# RECALL CAMPAIGN BULLETIN

NTB09-038

## VOLUNTARY SAFETY RECALL CAMPAIGN 2003 – 2007 NISSAN MURANO ENGINE AIR INTAKE DUCT

**CAMPAIGN ID #:** R0902  
**NHTSA #:** 09V-169  
**APPLIED VEHICLES:** 2003 – 2007 Murano (Z50)

Figure 4

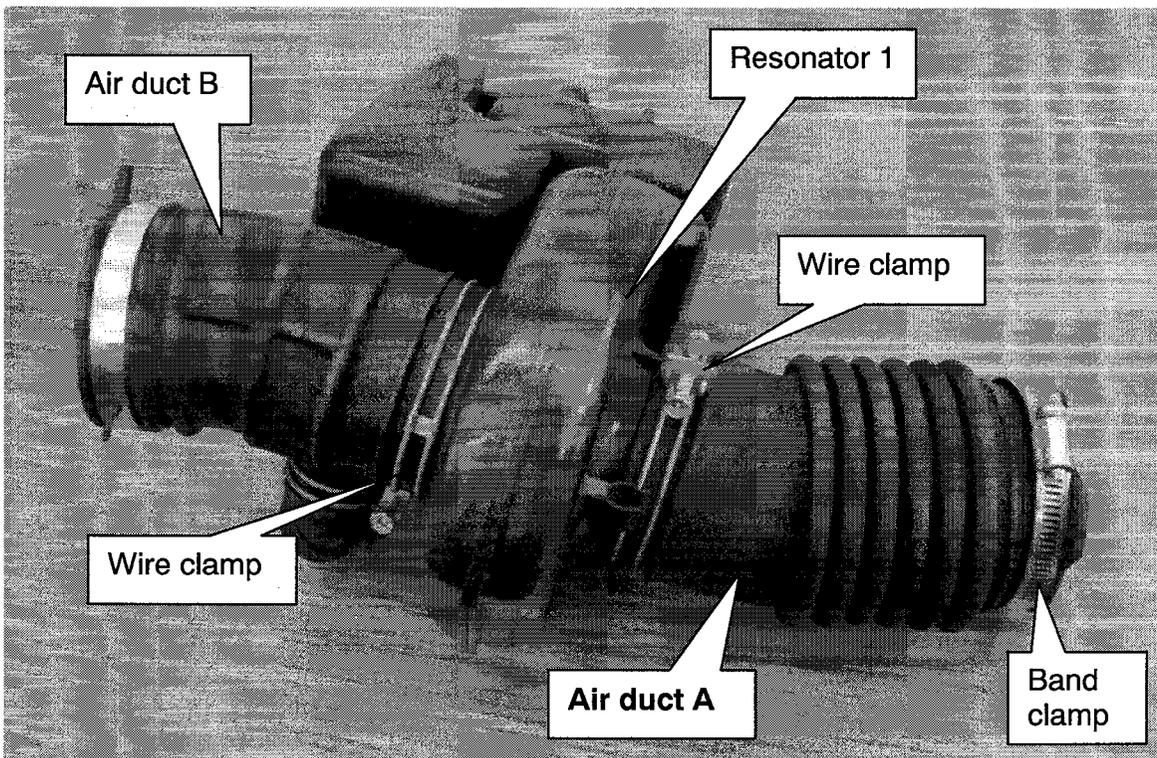
7. Disconnect / remove air duct A from resonator 1.

8. Swap the band clamp from the old air duct A to the new air duct A.
- Use the original band clamp.
  - Band clamp goes on the throttle body end of air duct A.
  - Make sure the clamp is aligned correctly (rubber stud through hole in clamp as shown).

Figure 6

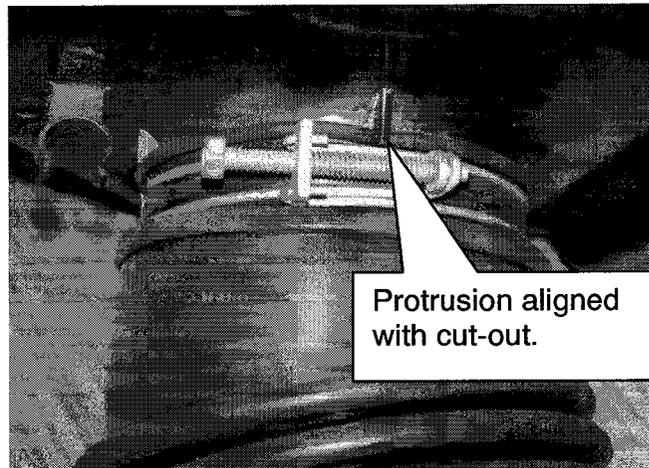
11. Connect the new air duct A to resonator 1.
- Make sure the slot (cut-out) in the duct is aligned with the largest protrusion on the resonator.
- NOTE:** There are 4 protrusions on the resonator, use the largest one to align the air duct.

12. Position and tighten both wire clamps (air duct A and air duct B).
- a. Position each wire clamp near the protrusion / cut out (see Figure 6).
  - b. Tighten the clamps to: 2.2 - 3.0 N-m (0.22 - 0.30 kg-m, **20 – 26 in-lb**).
